Author's Reply to Anonymous Referee #1

The authors appreciate the useful and constructive comments that helped to improve the submitted manuscript:
High current speed events in a harbor channel driven by resonant sub-hourly sea level dynamics: an example from Varna, Black Sea

RC1: 'Comment on egusphere-2026-1731', Anonymous Referee #1, 03 May 2026

Fig01

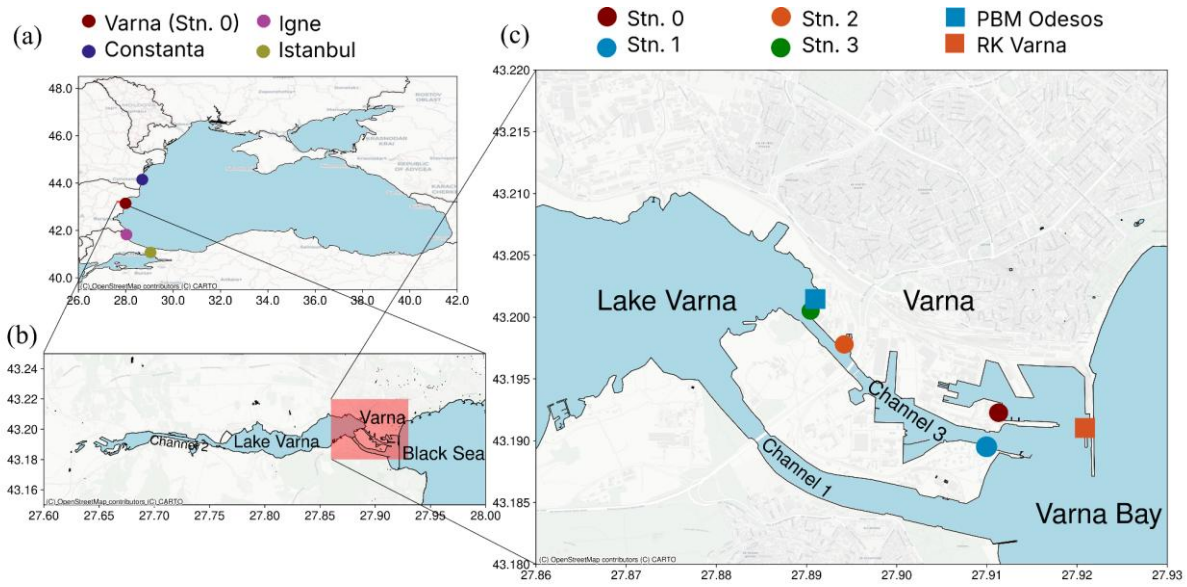
L102-104 (Figure 1): What does PBM and RK stand for in the subplot (c)? Is the date for last visit the link in the caption needed here?

Reply: The caption of Figure 1 is extended to note that the observations shown in the subplot (c) are presented in Table 1. Regarding the link https://marine.copernicus.eu/ we think it is not necessary to present the date of the last visit, since we do not present any sub-link to the parts of the Copernicus Marine Service, which is a permanent activity.

Figure 1. (a) Location of the study area, shown on the map of the Black Sea. The western coastal stations where data are shared within the Copernicus Marine Service https://marine.copernicus.eu/ are indicated on the map. (b) Map of the Varna region. (c) Map of the study area displaying the locations of the observation sites. Details of observation points are given in Table 1.

Fig02

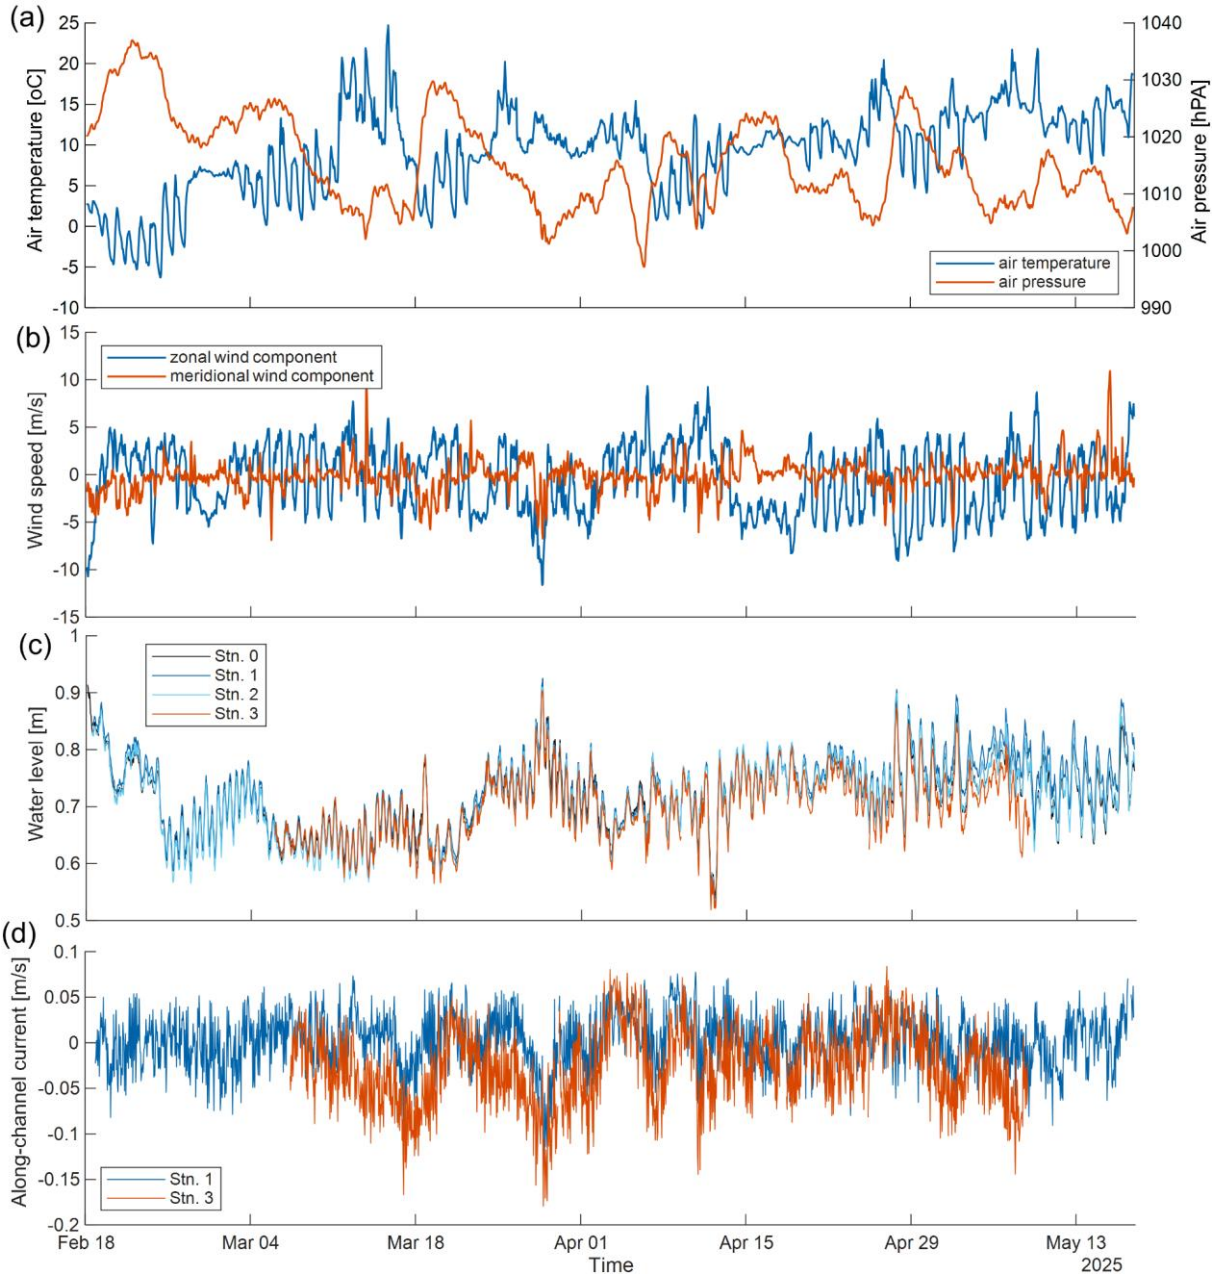
L172-173 (Figure 2): From which station are the measurements in pane (a) and (b)? Why are only Stn. 1 and Stn. 3 presented in (d) and not Stn. 2? Also, there is no need to write the x-label at all subplots since they have the same x-axis, this will save some space. Furthermore, I don't know if the figures are of good quality since inserted into the text, they seem a little bit blurry but that can be the result of rendering. This, and also other, Figures have a secondary x-axis, which means in MATLAB, that the year is lower than the ticks. This is not the problem when everything is clear, but since you have 4 subplots here the extra space, that you would save if you turned off the x-axis labels for all but the last subplot is large. Ticks can be switched off because you have the same x-axis for all plots.

L176: Which subplot?

Reply: We have redrawn the figure as recommended. Regarding Stn. 2, the data showed similar general current-velocity patterns to Stn. 1 and 3, but it is not included in panel (d) because the current-velocity measurements at times exhibited drift and were considered less representative of the channel flow. This was most likely due to mechanical and/or magnetic disturbances at the sensor location. To avoid over-interpreting measurements with potentially more uncertainty, only the results from Stn 1 and 3 are presented for the velocity. The figure caption was reformulated to:

Figure 2. Time series of meteorological and oceanographic data with 1-hour resolution. (a) Air temperature and air pressure, (b) zonal and meridional components of wind speed, (c) water level and (d) along-channel current speed (positive from lake to sea). Data from RK Varna (a, b), stations from Stn. 0 to Stn. 3 (c), and Stn. 1 and Stn. 3 (d).

Reply: All the subplots in Fig. 2 used filtered data. Their recording interval was less than 1 hour.

Fig03

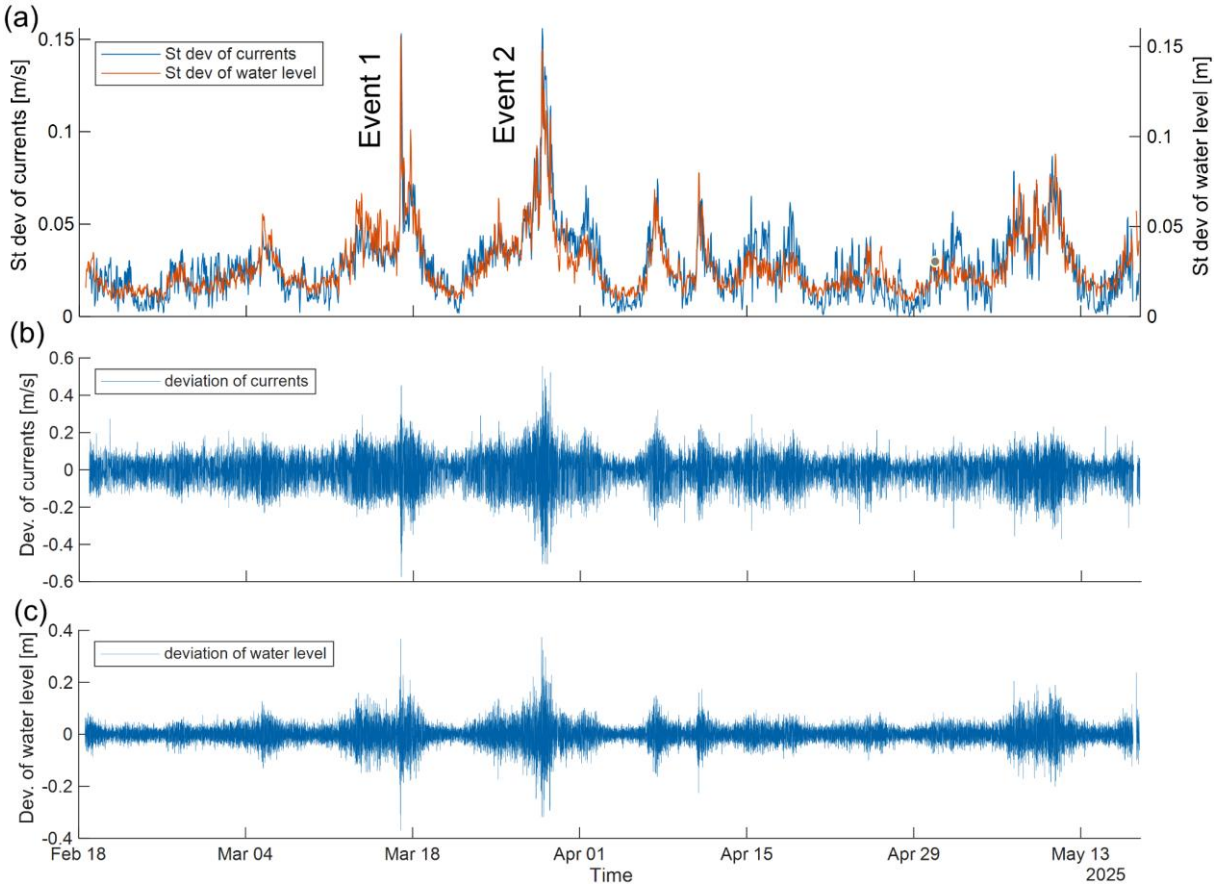
L241 (Figure 3): Same for x-label as before and for the titles of subplots…

Reply: We have redrawn the figure as recommended.

Fig04

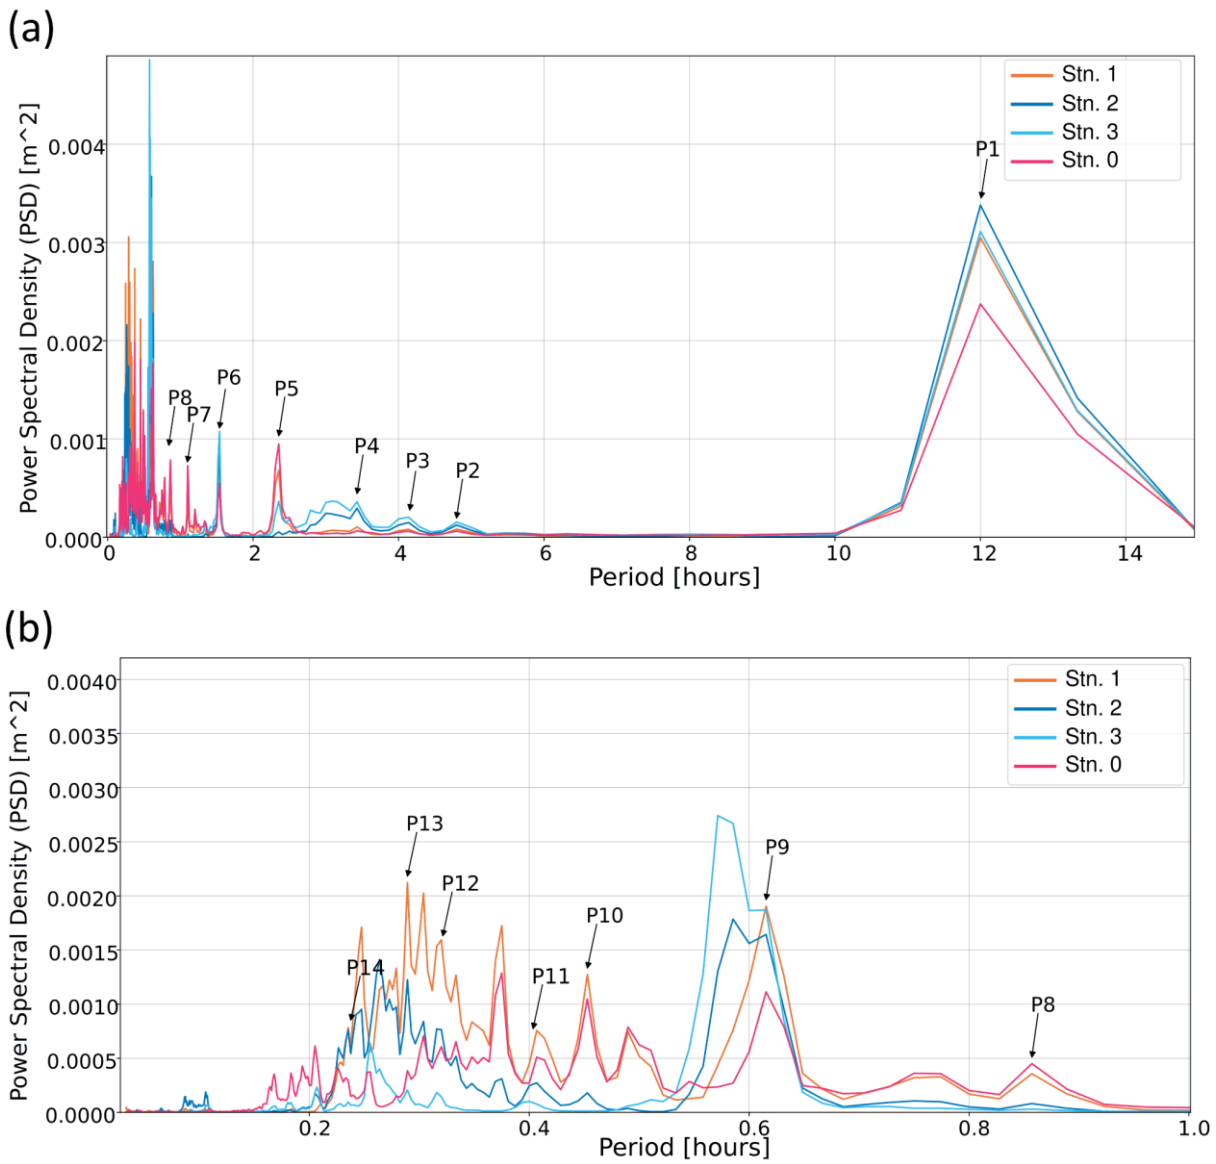
L257-258 (Figure 4): It would be clearer to note (a) than say what is presented in (a), than (b) and than what is presented in (b) not the caption first and letter of the subplot later. Also, the size of the font is really small. The y-label is not readable.

Reply: We have redrawn the figure as recommended and have rewritten the figure caption.

Figure 4. (a) PSD of water level at the four measurement sites of the channel in the range of periods from 2 min to 15 h using a 6-day Welch segment. (b) PSD for periods from 2 min to 1 h, computed using a 1-day Welch segment length to better resolve higher-frequency variability.

Fig05

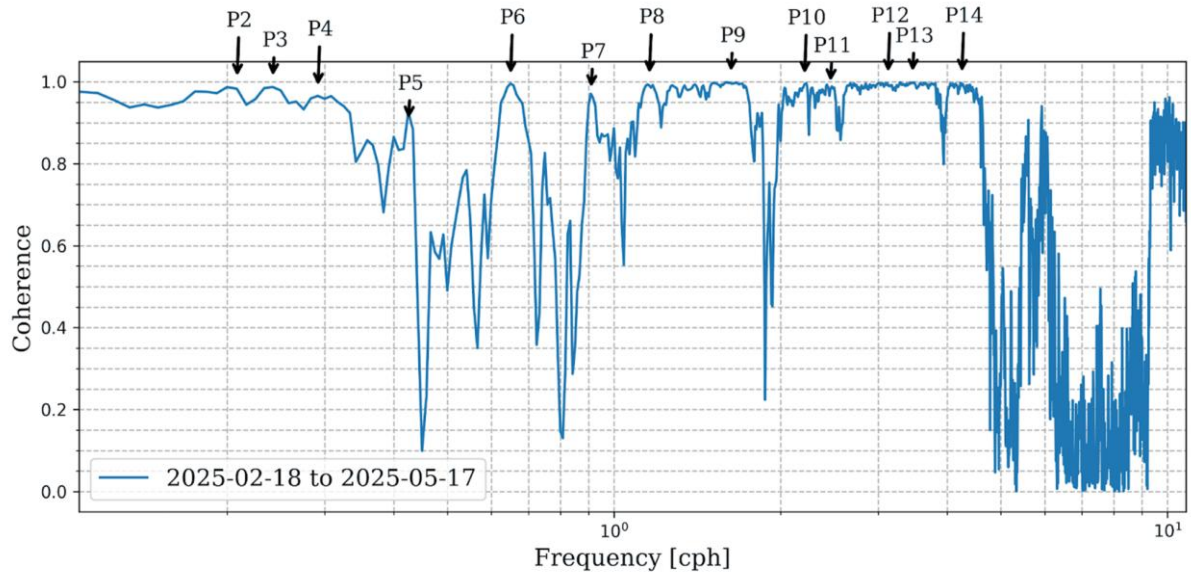
L154-156: Although this is a known method, it would benefit the paper if there was an extra sentence or two just explaining a little bit more about coherence since it is talked about and directly presented in Fig. 5. Like, what coherence = 1 means.

Reply: The text has been extended. Revised text starting from line 154 is:

In addition, a comparison between pairs of stations in the frequency domain was performed using coherence analysis. The comparison included coherence calculations between all stations using 5-day segments and a 2-day overlap. Coherence quantifies the strength of the linear relationship between two time series as a function of frequency. Its values range from 0 to 1, where values close to 1 indicate a similar variability at a given frequency, while values close to 0 indicate little or no linear relationship. Hence, high coherence suggests that the stations are responding to the same physical forcing at a given timescale.

Fig06

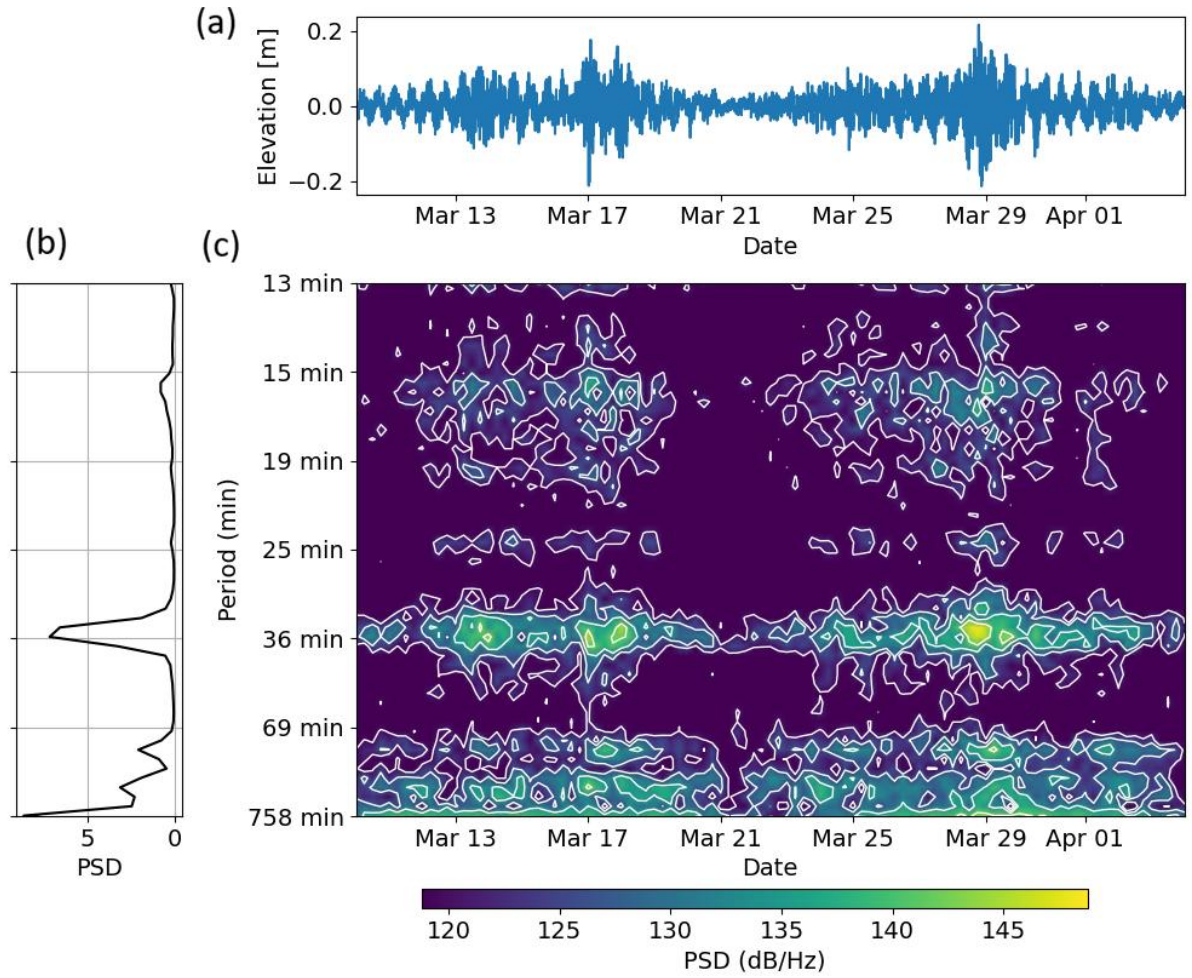
L261: Why was specifically Stn. 1 chosen and not any other station?

L290 (Figure 6): The titles of the subplots seem redundant since everything is explained in the caption - the titles only add more clutter to the plot. Everything else is the same as for most other Figures... small font, etc.

Reply: Water levels at all stations were well correlated, especially over longer periods (lines 225-228); therefore, we considered it sufficient to present an example from a single station. The revised text is:

Further insight into the time-dependent character of oscillation amplitudes was gained through spectrogram analysis, which used the short-time Fourier transform (STFT) with a 12 h window and 6 h overlap over successive segments. A spectrogram example is given in Fig. 6 based on data from Stn. 1.

Reply: We have redrawn the figure as recommended.

Fig09

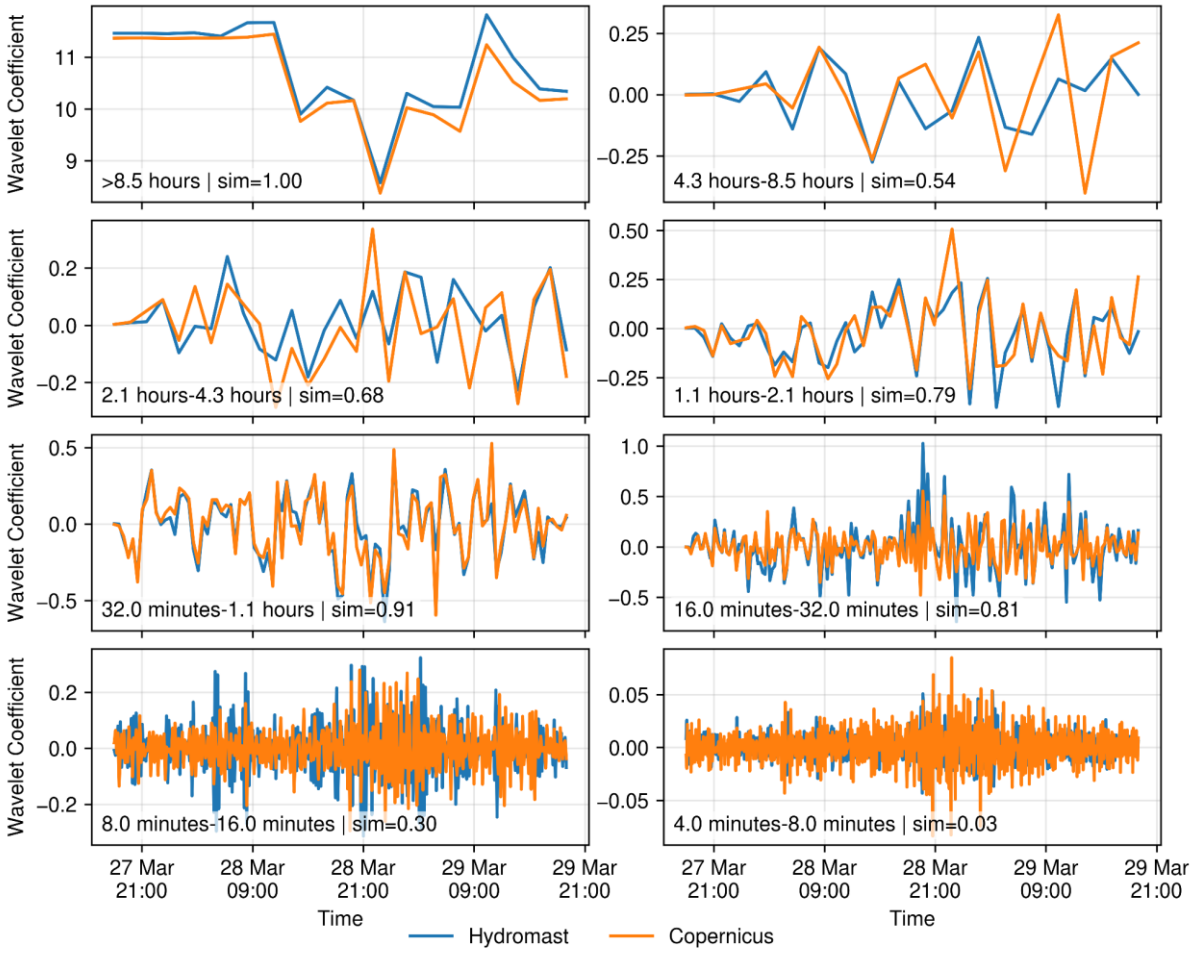
L320 (Figure 9): Very poor quality of Figure 9. X-axis is very bad, in some instances the ticks overlap - last row of the Figure. There is also a lot of empty space between subplots.

Reply: We have redrawn the figure as recommended.

Fig11

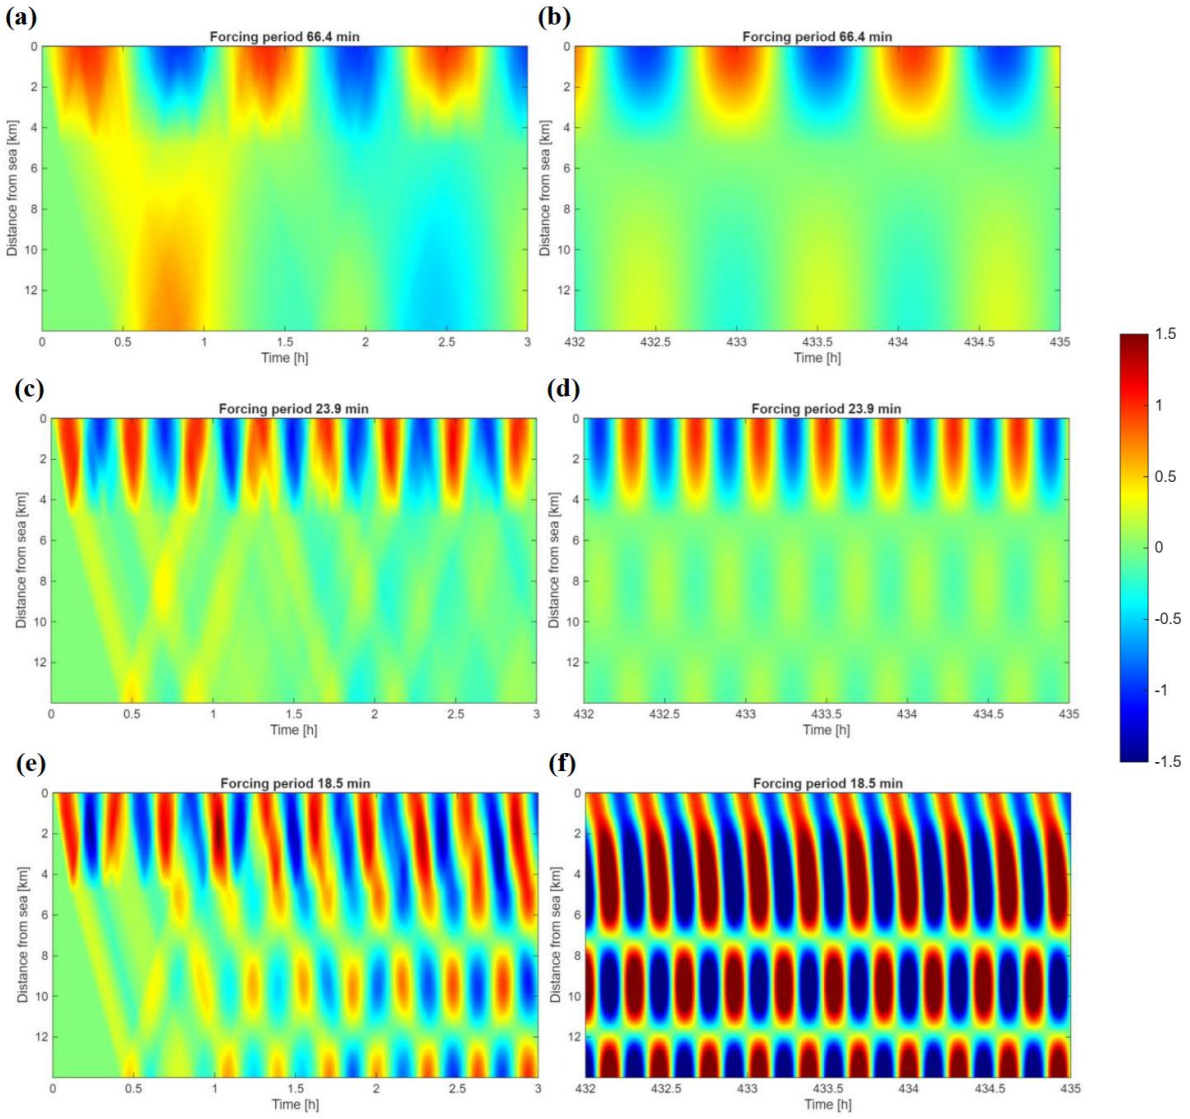
L397 (Figure 11): Where is the colorbar?

Reply: The colorbar has been added.
